Liberty Knitwear Ltd. Unit-2 (Extension 2)

10 July 2023

Observations

Beam adequacy check is not provided in design report

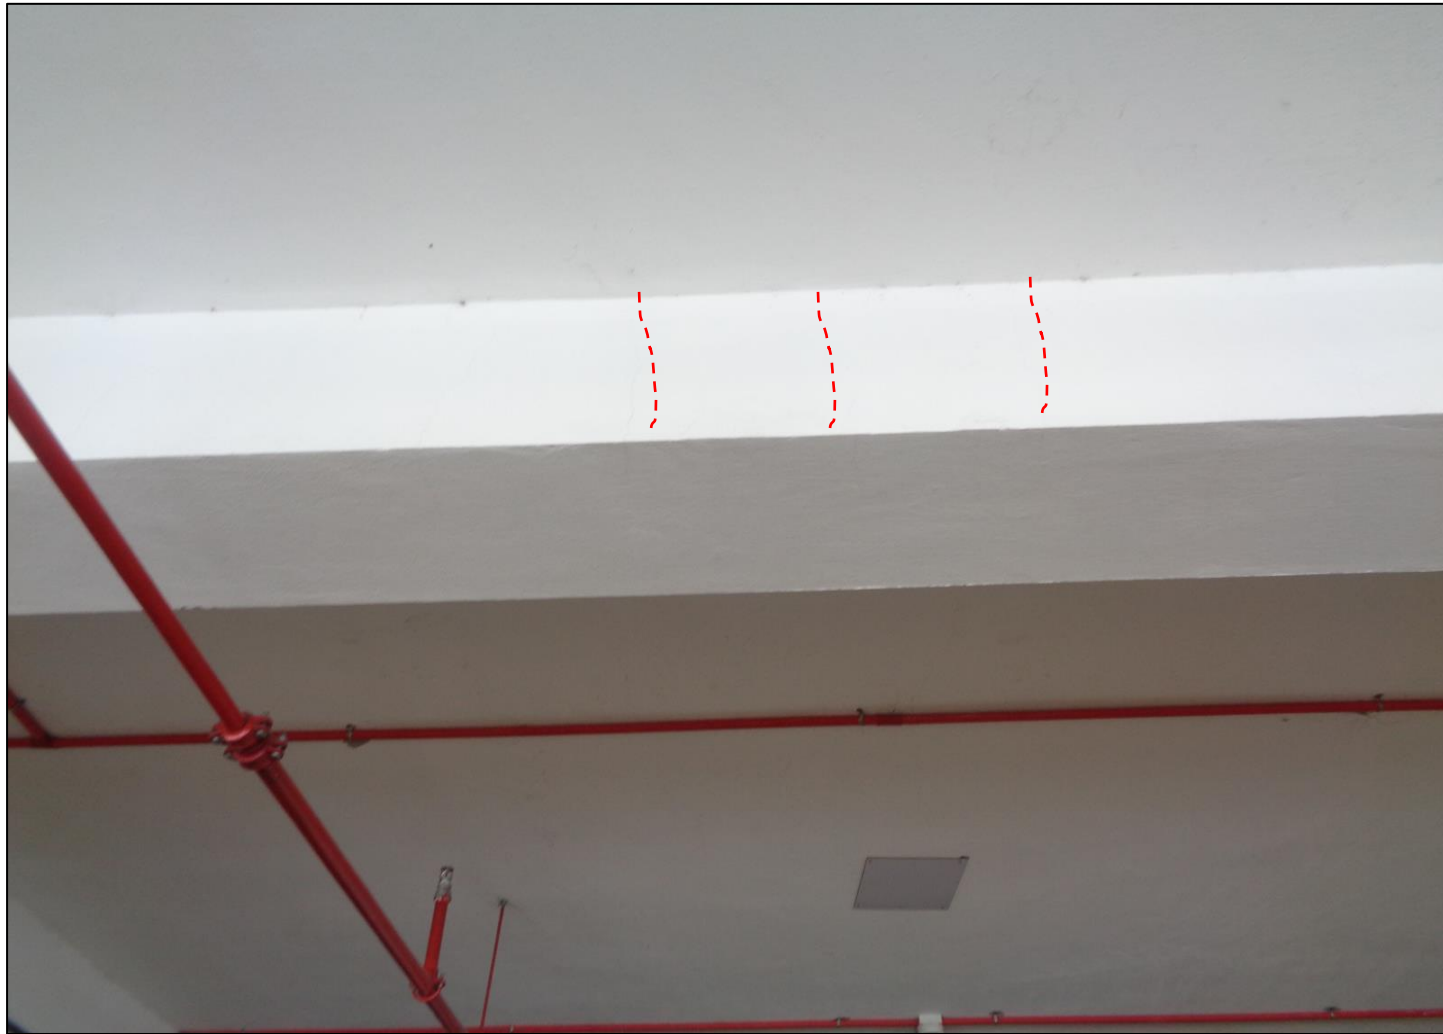
Beam adequacy check is not provided in design report. Building engineer is required to update the design report including all requirements of BNBC 1.9.1.

Cracks on roof beam

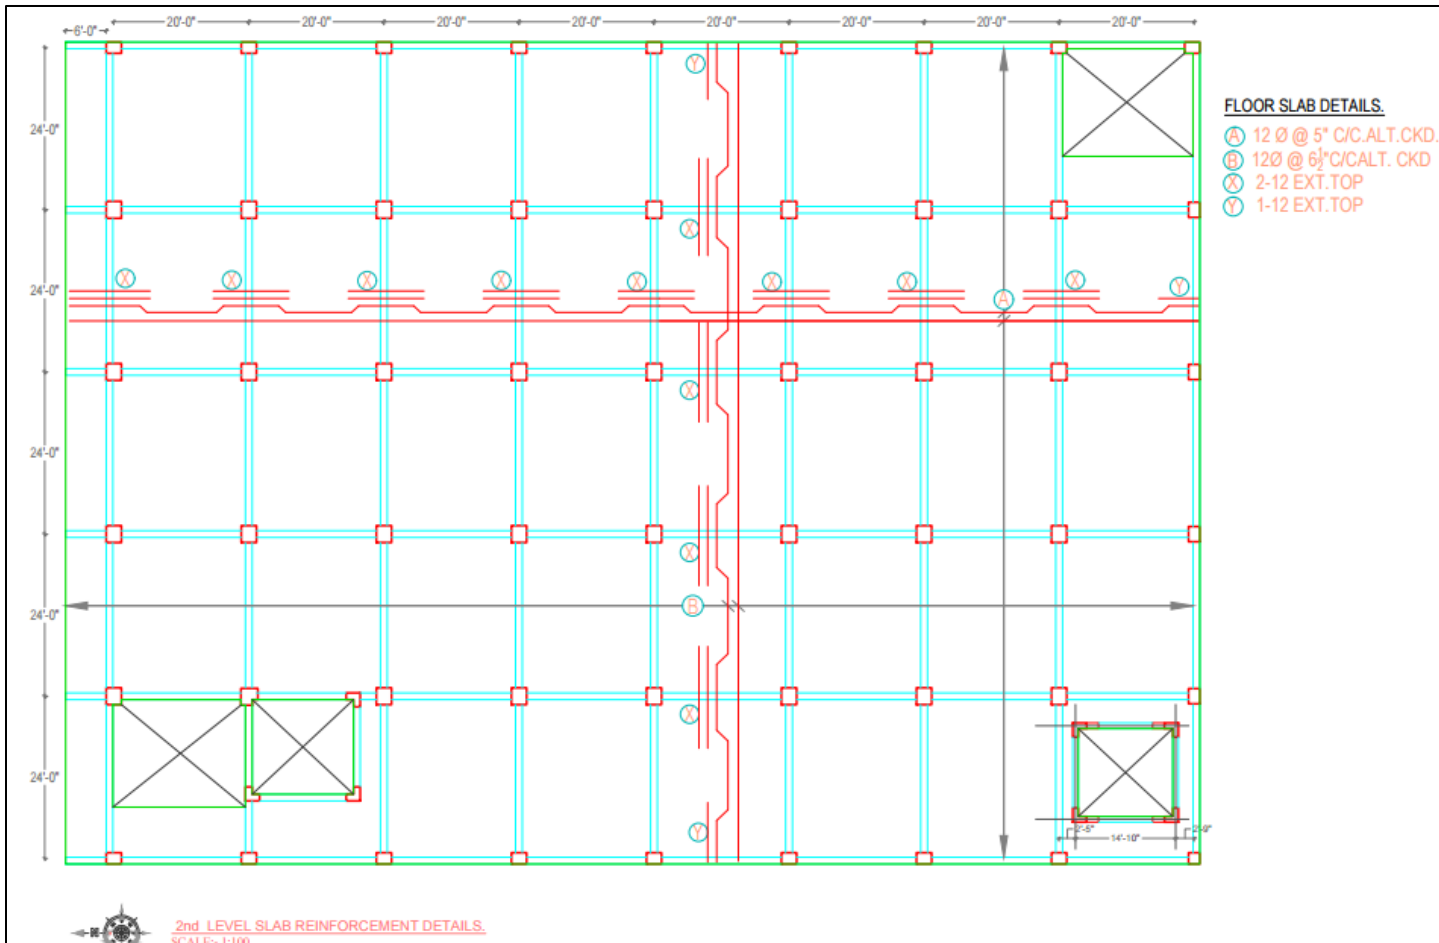
Hairline cracks were observed on roof beams. . Building engineer is required to investigate the cracks and carry out suitable repair work as per recommendation of investigation report.
